RE: **PETITION NO. 1600** – TRITEC Americas, LLC notice of election to waive exclusion from Connecticut Siting Council jurisdiction, pursuant to Connecticut General Statutes §16-50k(e), and petition for a declaratory ruling, pursuant to Connecticut General Statutes §4-176 and §16-50k, for the proposed construction, maintenance and operation of a 0.999-megawatt AC solar photovoltaic electric generating facility located at Parcel No. 30-2-74-40 Chamberlain Highway, Berlin, Connecticut, and associated electrical interconnection. **Final Decision.**

Petition No. 1600
TRITEC Americas, LLC
0.999 MW AC Solar Photovoltaic Electric Generating Facility
Parcel No. 30-2-74-40 Chamberlain Highway, Berlin, Connecticut

Staff Report
May 9, 2024

Site Plan

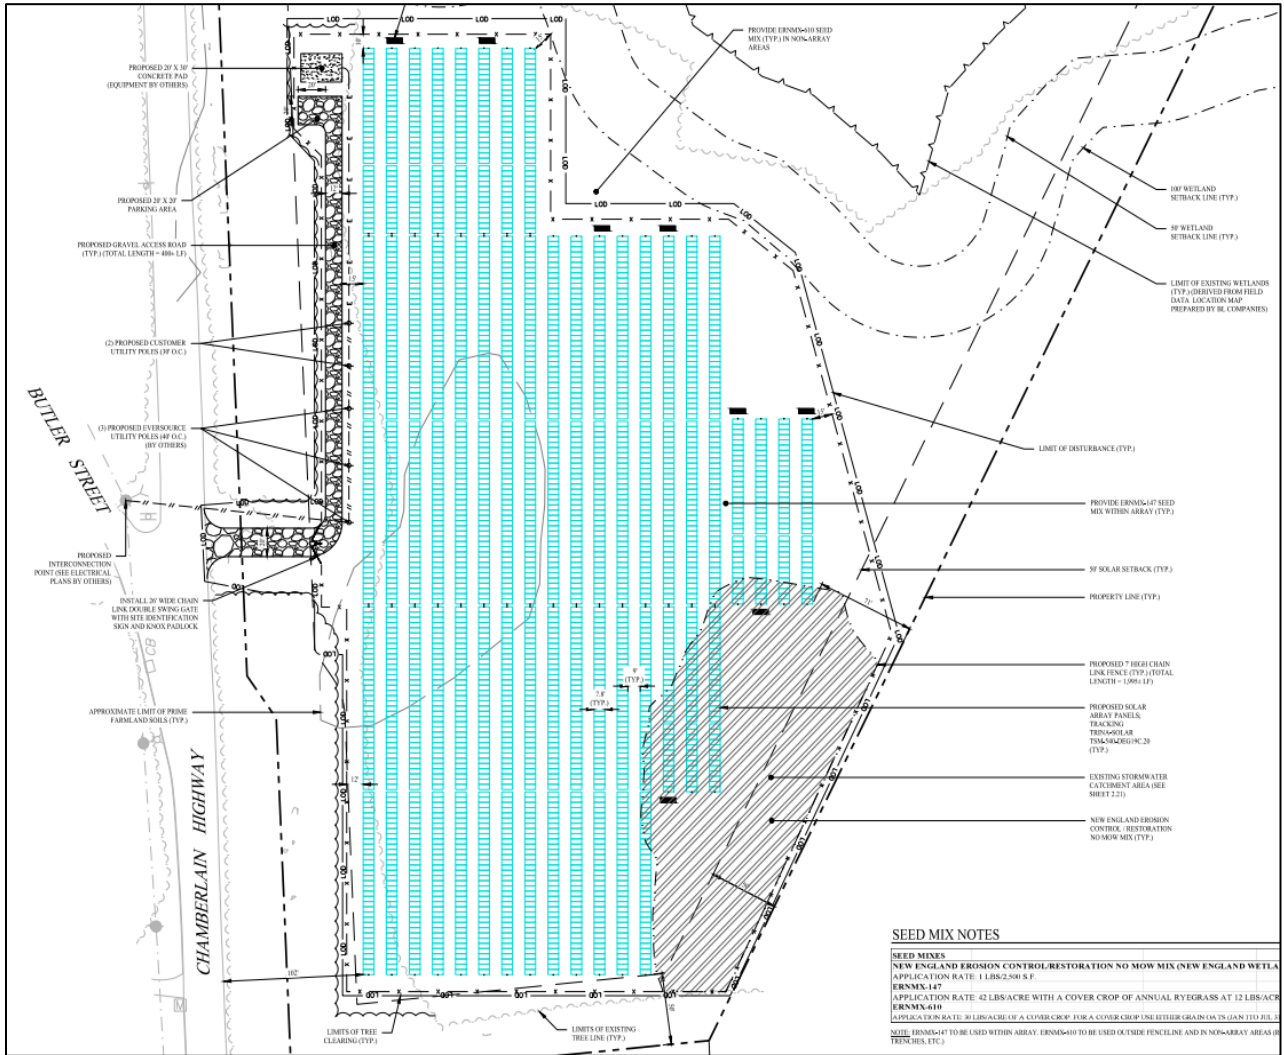
13. Install the transformer with a low-level oil monitor and alarm;
14. Shift the location of the electrical pad further to the east to increase the distance from the nearest residential property line and submit a revised site plan prior to commencement of construction;

The utility poles were initially clustered with 10-foot spacing adjacent to the equipment pad, approximately 80 feet from Chamberlain Highway. To reduce the visual effect of the clustered poles, in response to the Council's interrogatories, TRITEC submitted a revised site plan with 30 to 40-foot pole spacing, dependent on Eversource's interconnection detail.

Initially, the construction limit of disturbance (LOD) and perimeter fencing was approximately 60 feet and 75 feet, respectively, from the wetland. Based on a Council interrogatory, TRITEC revised the site plan increasing the distance of the LOD and perimeter fencing to 90 feet and 95 feet, respectively, from the wetland. The facility site design would comply with DEEP Stormwater Permit Appendix I.
